**In The Drawings**

Please amend FIGs. 3 and 4 as shown in red ink on the attached sheets.

FIG. 5

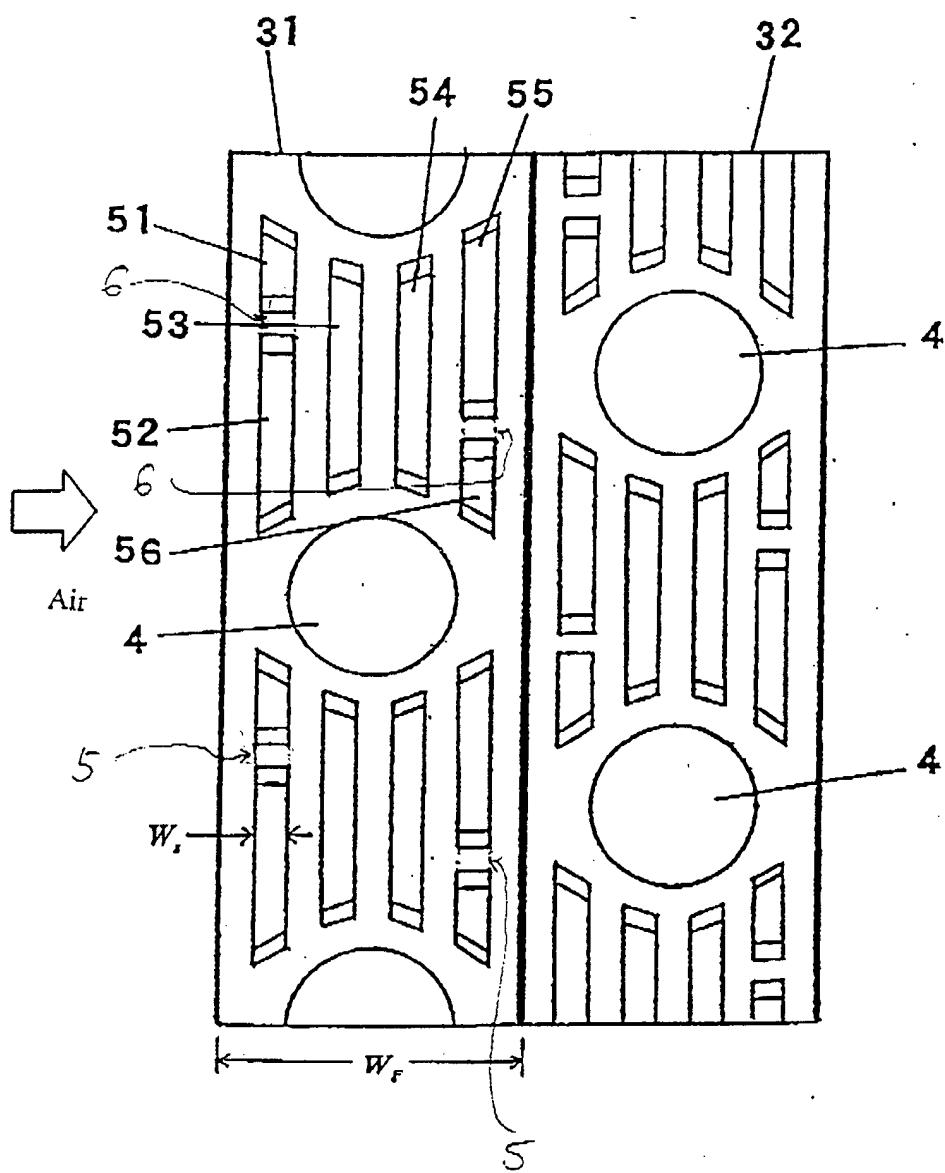
Also please add a new drawing Fig. 5.
